**Addendum No. 1
To
City of Auburn, Maine
2024-033 NSBA Rink #2
March 7, 2024**

This addendum amends and /or supplements the bid documents as indicated below. Only these items alter the bid documents. Any verbal discussions or responses are hereby declared null and void. Please acknowledge this addendum on the Bid Form.

Exhibit 1

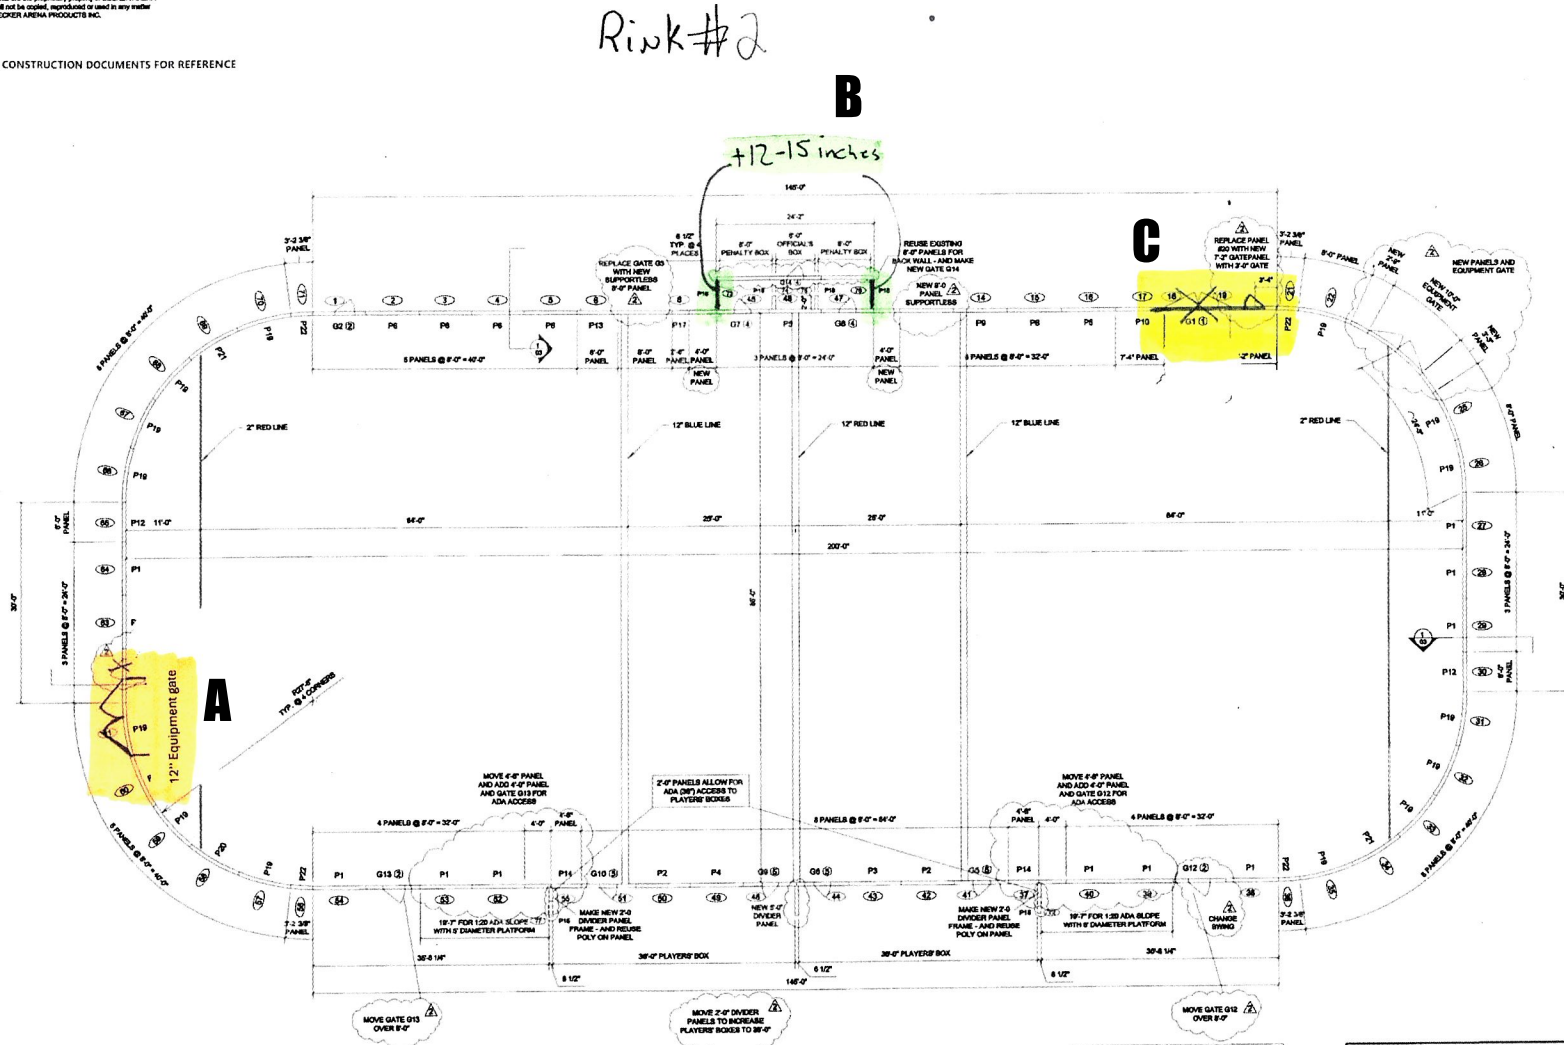
A: Staff would like to remove the door behind the goal in the front of the rink, and add a Zamboni door to the right (12ft door)

B: Penalty box will be 12" – 15" wider

C: Removal of unused door due to ramp placement.

Drawing Name:
 Rink Refrigeration Plan

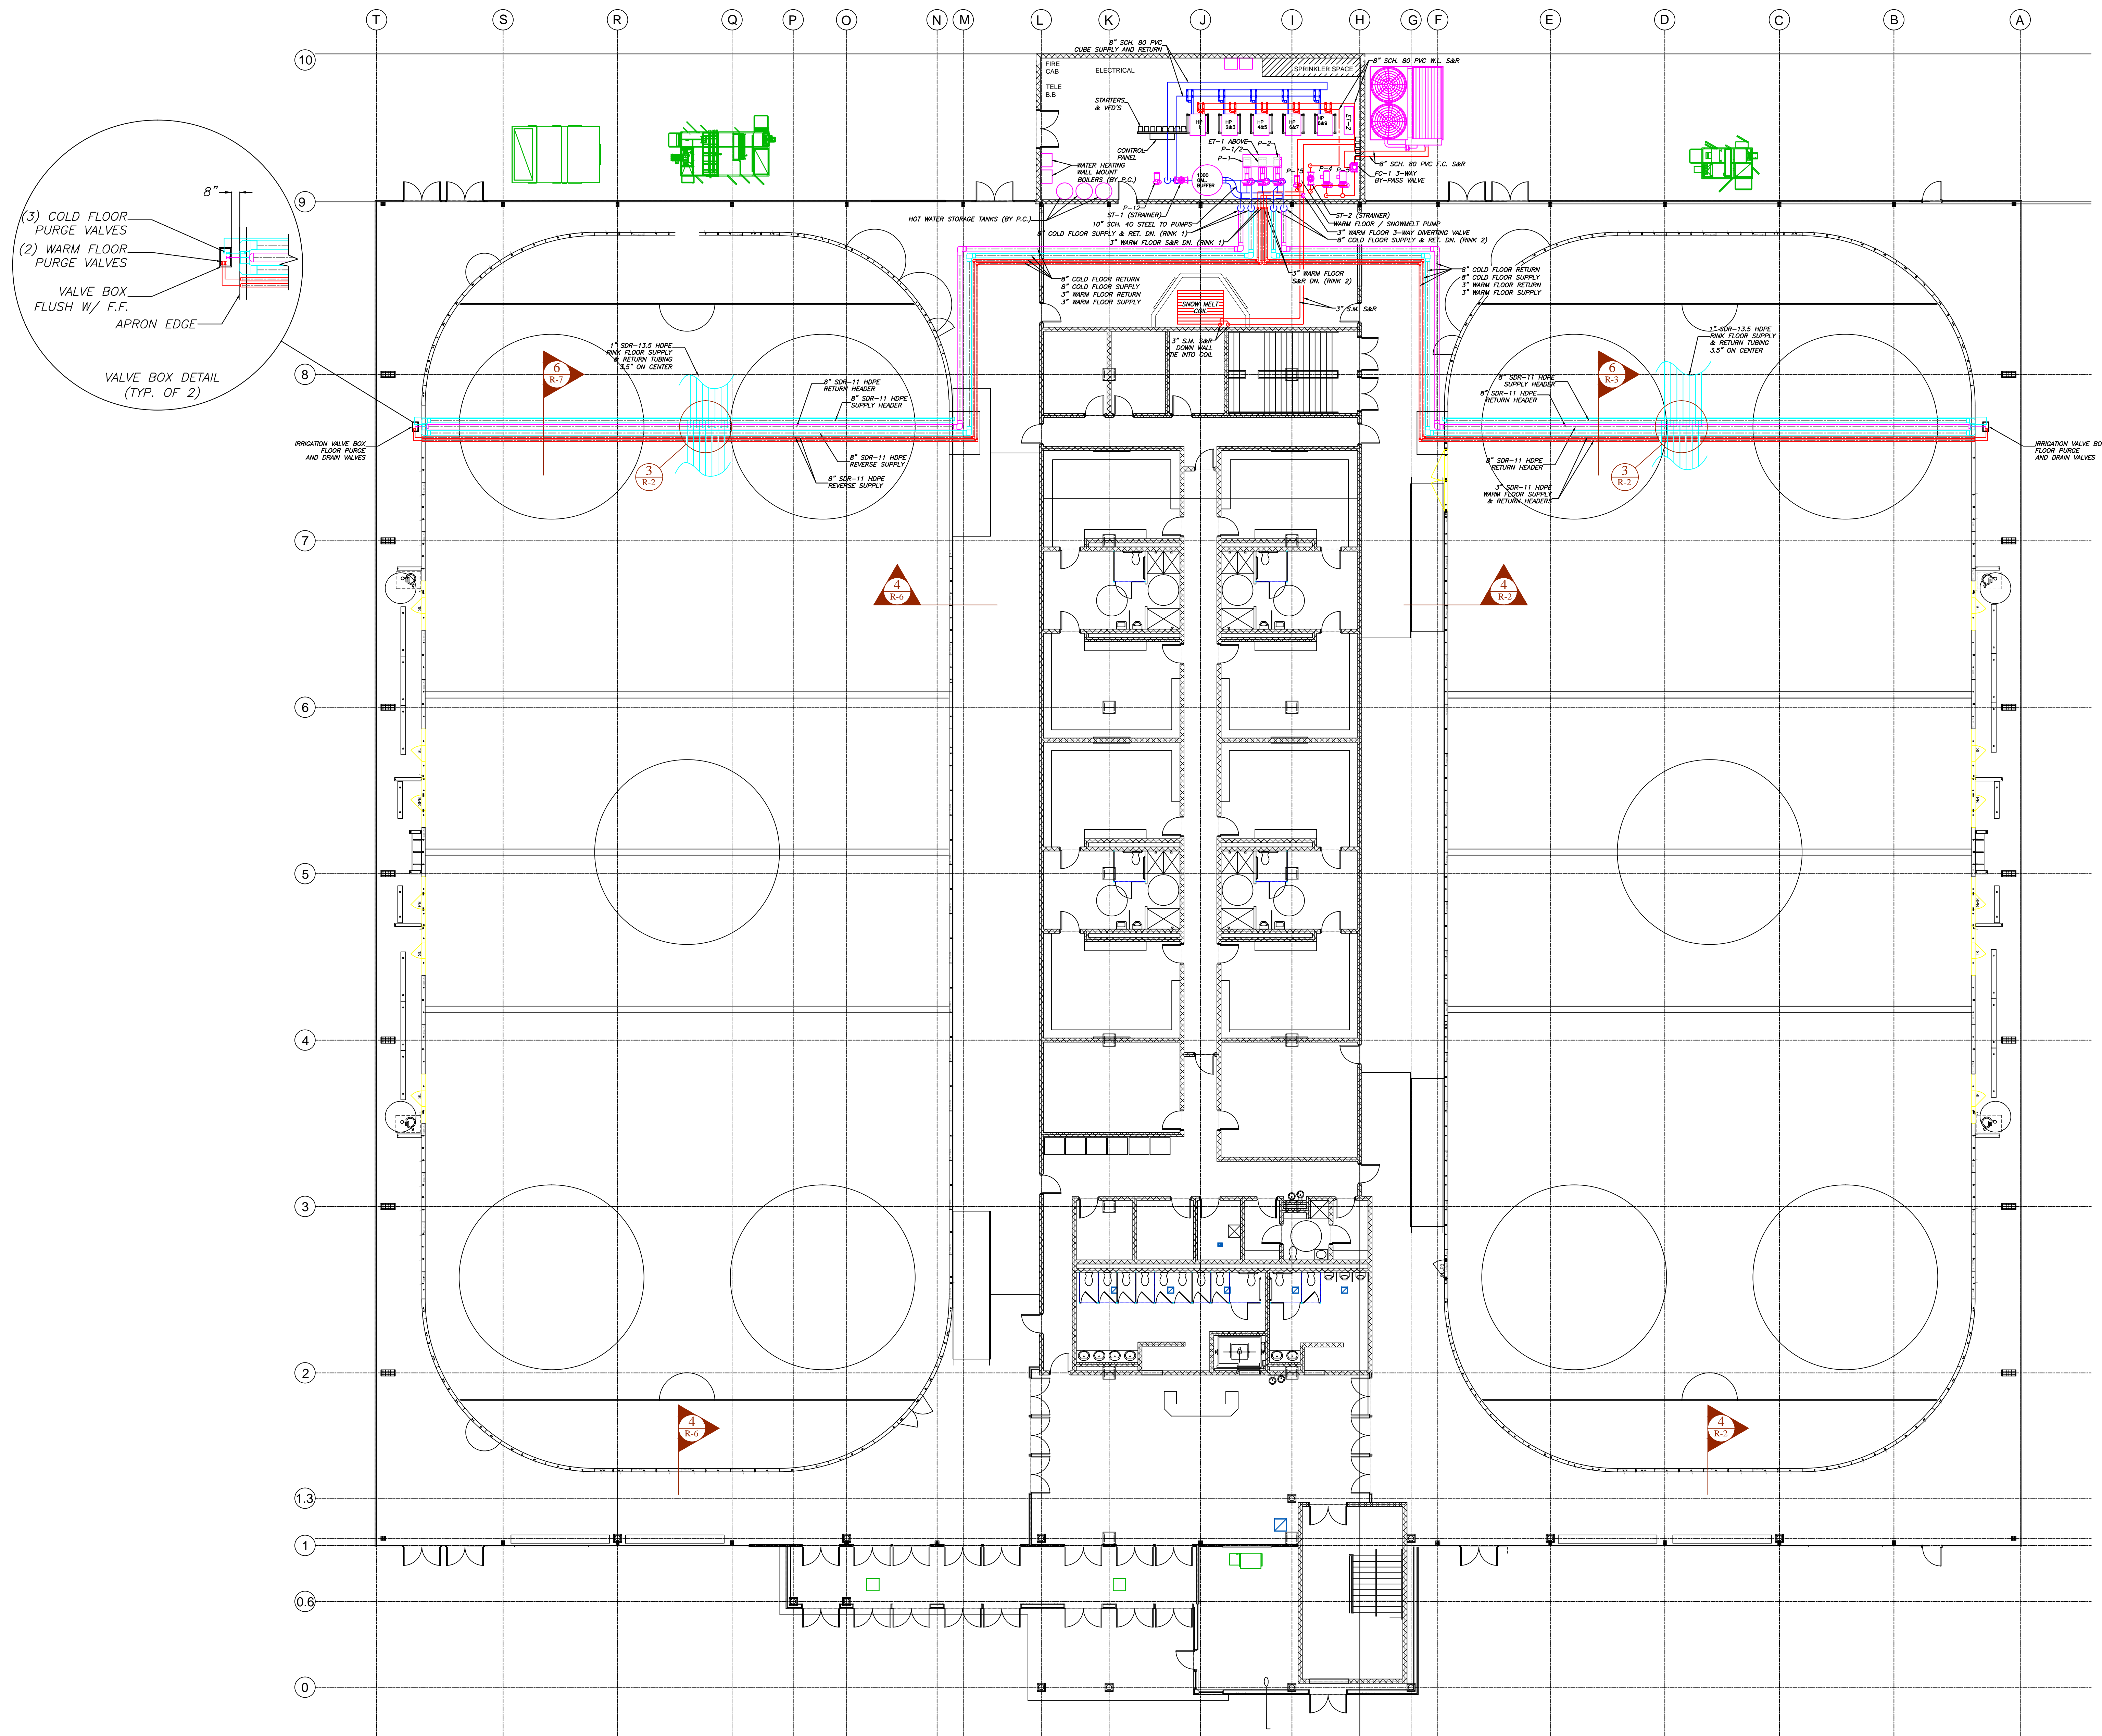
Question: Header location

Answer: *See Exhibit 2*
